IN THE DRAWINGS:

REMARKS

Reconsideration of the above-identified application, as amended, is respectfully requested.

Figure 1

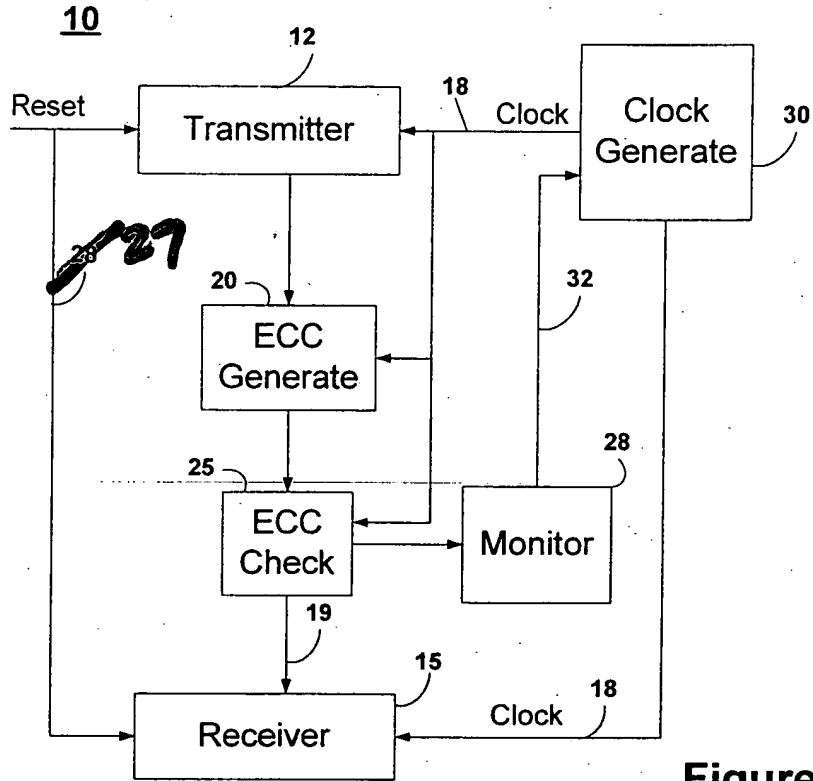
Please enter substitute drawing sheet 1 of 2 provided herewith, comprising Figures 1 and 2 that have been modified as indicated to correct informalities with respect to element numbers 28 and 30. These drawings are labeled as “Annotated” sheets as per the Examiner’s indication.

Further in the Office Action, the Examiner alleged that the amendment to drawing sheet 1 including Figures 1 and 2 that was submitted in applicants prior response of December 28, 2004 was improper as the amendment constituted submission of an "Annotated" drawing sheet and the amended drawing sheet was not so labeled. Applicants respectfully request entry of the same drawing amendment, this time, with the designation as an "Annotated" drawing sheet. It is respectfully requested that the Examiner remove this drawing objection.
